Stadium Australia- SSD10342- Stormwater Management

Civil Works-Stormwater Drainage Report – ADDENDUM 1

Civil Works-Stormwater Drainage Report – ADDENDUM 1

CIVIL WORKS - STORMWATER DRAINAGE LAYOUT - KEY PLAN

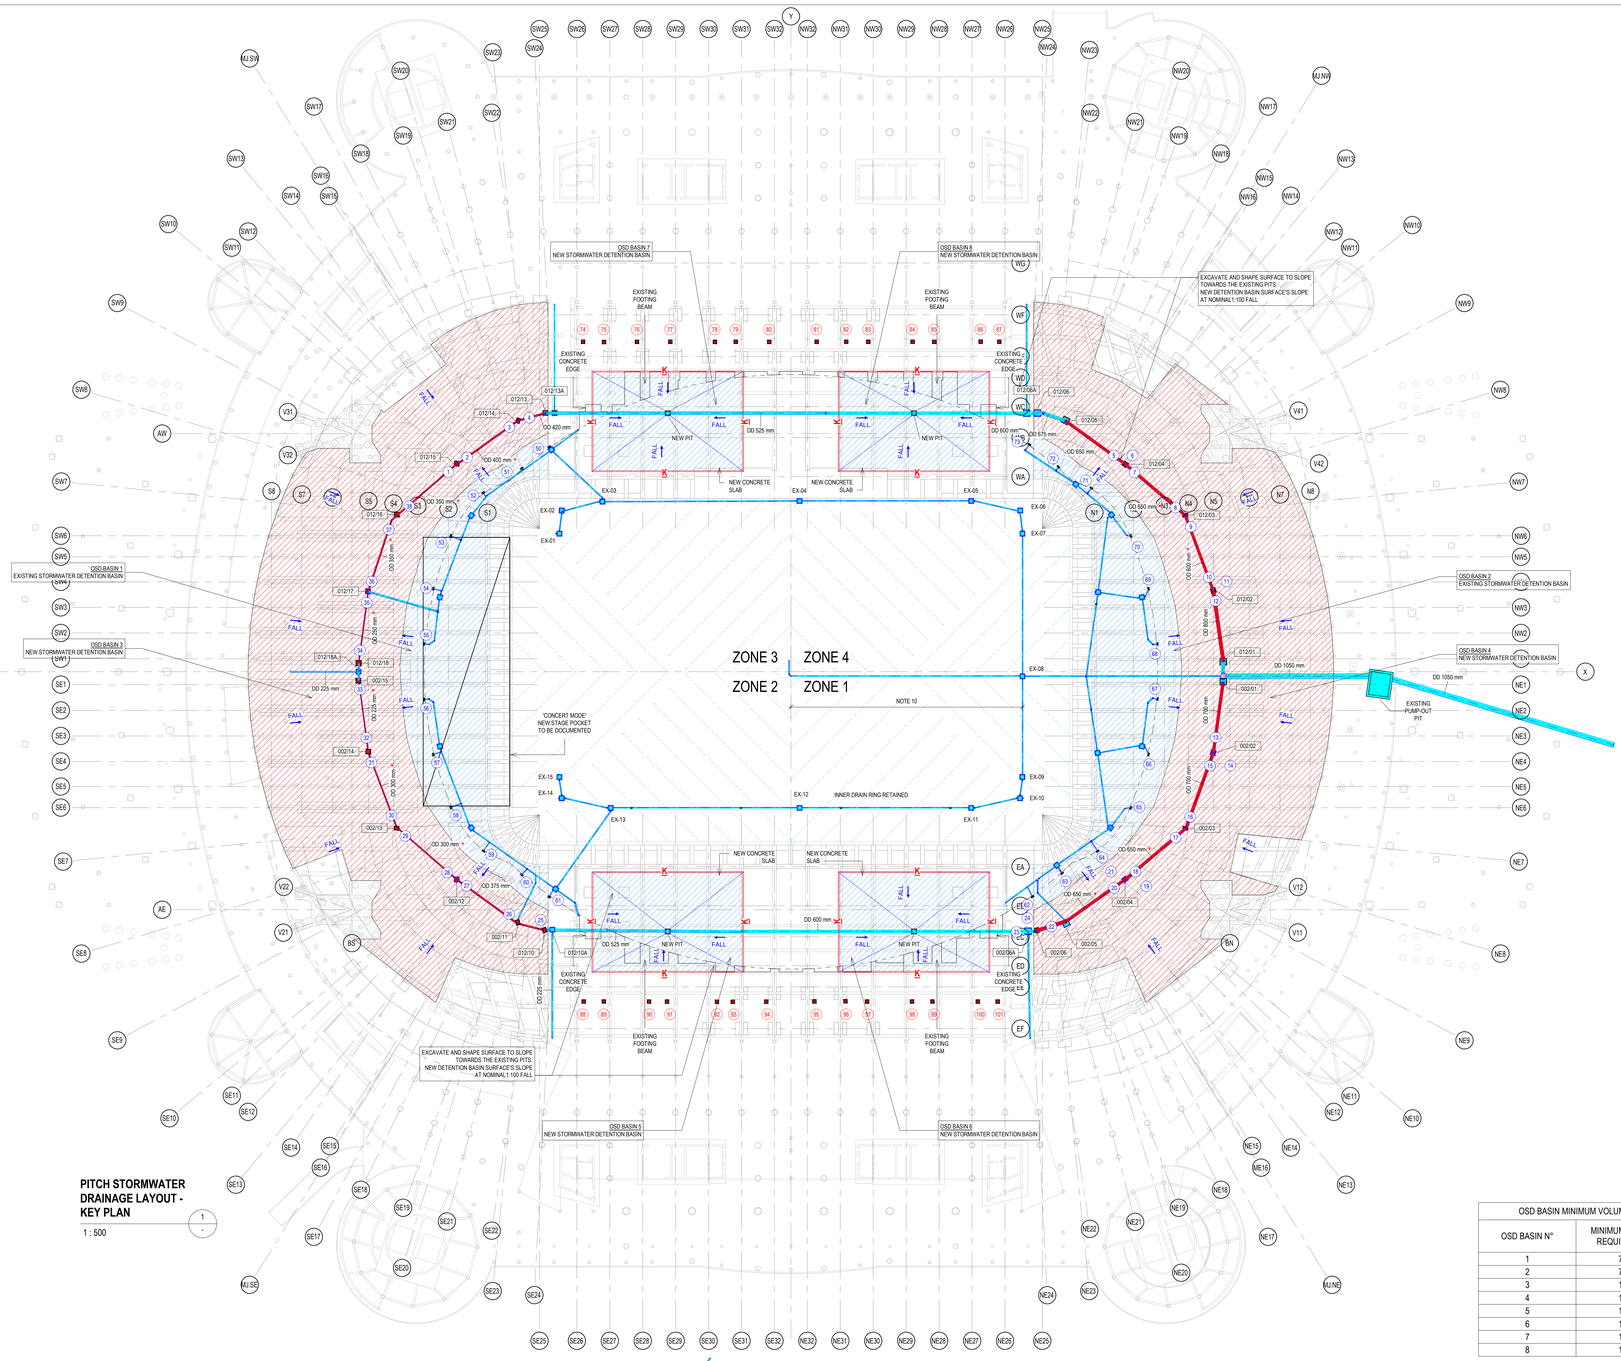
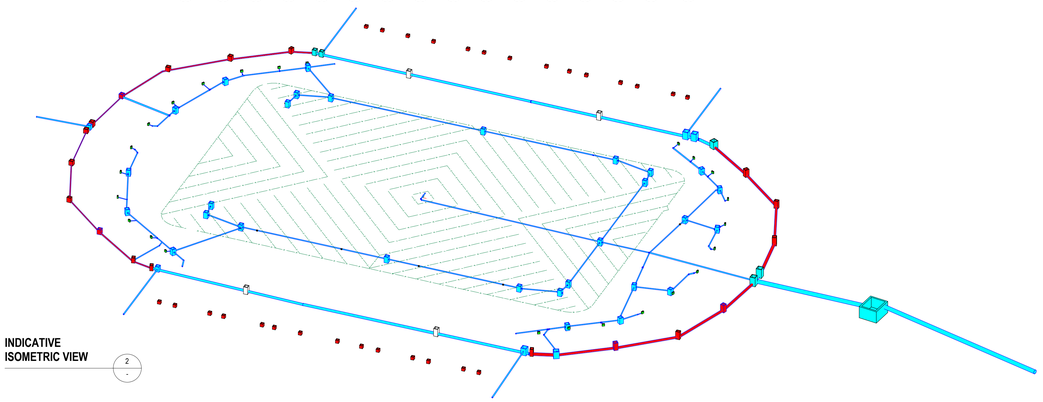
- The stormwater detention basins provided in the design cater for 100% of the volume of the stormwater detention required.
- The field of play is not designed to be flooded during the required storm events.
- The Maffeis Engineering design will maintain stormwater detention under the North & South Stands and, further, provides increased detention volume.
- The submitted 'Civil Works-Stormwater Drainage Layout' drawing SAR-SD-20-0100-02 identifies stormwater detention basin locations and required storage volumes to meet the design stormwater detention requirement.
- The maximum discharge rate from the site following completion of the works is unchanged from what is currently the discharge rate including for the 100 year ARI event.

The Addendum highlights that the Aurecon 'Stormwater Management Plan' dated 16th August 2019 (Aurecon reference 255576), in regards to the submitted design, is in error when it states in its **Section 3.1**

- *'..the stadium's stormwater drainage under the northern and southern stands where it is envisaged that the existing under-stand drainage system will be removed and replaces with a new in-ground network…*
- *'...On-site detention will no longer be provided under the stands for major storm event but would rather temporary overflow on to the field before draining out...'*

- MOVE SOIL AND EXCAVATE/CONSTRUCT NEW KERBS AS REQUIRED TO RE-FORM THE EXISTING DETENTION BASIN TO DELIVER A NOMINAL 1:100.
   NEW DETENTION BASIN SURFACE'S SLOPE AT NOMINAL 1:100 FALL FROM THE "EXTERNAL" SIDE TOWARDS THE PIT.

- PITS TO REMAIN AT EXISTING LEVELS.
   - GRADE THE NEW " NORTH" AND "SOUTH".
9. NEW ON SITE STORMWATER DETENTION BASIN AREA:
   - EXCAVATE AND SHAPE SURFACE TO SLOPE TOWARDS THE EXISTING PITS. NEW DETENTION BASIN SURFACE'S SLOPE AT NOMINAL 1:100 FALL.

12. REQUIRED "NEW OSD VOLUMES"
    A. NO RETRACTABLE ROOF: 180 m^3
    B. RETRACTABLE ROOF: 450 m^3
13. CONSTRUCT A "NEW KERB" (K) ALL AROUND NEW OSD BASINS N° 5, 6, 7 AND 8.
    SHAPE THE EXISTING GROUND SURFACE AND IMPORT FILL TO BUILD UP, TO DELIVER A NOMINAL 1 IN 100 FALL TO A "NEW PIT".
